NRC Staff Technical Issues And Questions for Generic Safety Issue 191

Office of Nuclear Reactor Regulation

Public Meeting

June 19, 2007

Issue #2: Small Strainer Submergence and Possibility of Flashing

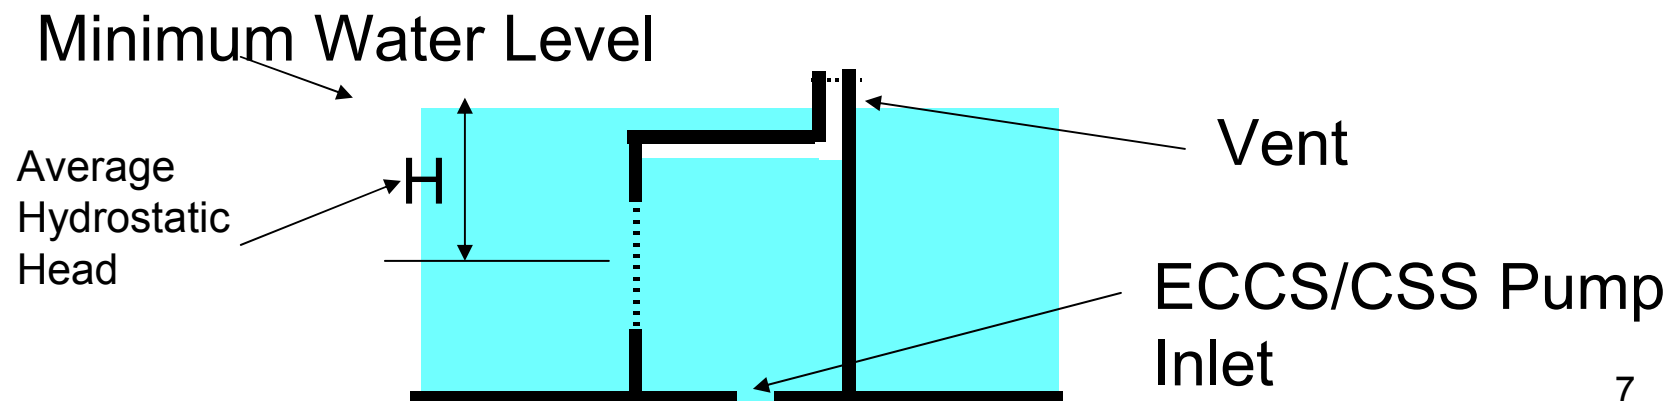
- During the early phase of the recirculation, the pool temperature is at or close to saturation temperature
- If the strainer head loss is greater than the minimum submergence, flashing and de-aeration may occur inside the strainer. The flashing and de-aeration may cause higher debris bed head loss, steam binding and pump failure
- NRC SE states that bulk flow void fraction downstream of the strainer surface should be less than 3%

Licensees should evaluate flashing and de-aeration by determining bulk flow void fraction downstream of the screen

Issue # 4 Circumscribed Flow Condition in a Debris-Filled Pit Geometry

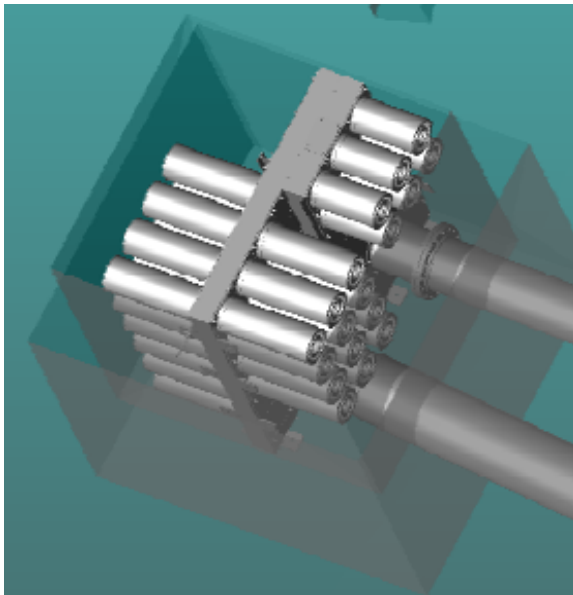
For plant strainers located in a pit which may be completely or partially filled with debris, a significant head loss could occur from the flow of fluid downward through the debris in the pit. If debris bridging occurs at the top row of the strainer array, high fluid velocity is expected through the debris bed at the entrance of the pit

1. Full-scale module testing performed to date has not adequately modeled higher velocity through the top layer of the debris at the entrance of the pit without modeling the entire stack of the strainer module
2. Neglecting the velocity of the downward flow through accumulated debris in the pit could significantly underestimate the plant debris bed head loss
3. Non-uniform distribution of the debris and the flow may increase the internal clean strainer head loss and the debris bed head loss due to different compression
4. Similar concern may arise for closely spaced floor-mounted strainers

- Scaling principle based on test versus actual strainer area ratio does not apply to the circumscribed flow condition in a debris-filled pit geometry
- Scaling principle based on test versus actual strainer area ratio may not be conservative for partially-filled pit geometry and close-spaced floor mounted strainer arrays
- Licensees need to evaluate the flow and debris distribution condition to determine whether retesting is necessary based on a proper scaling analysis specifically for these two debris distribution scenarios
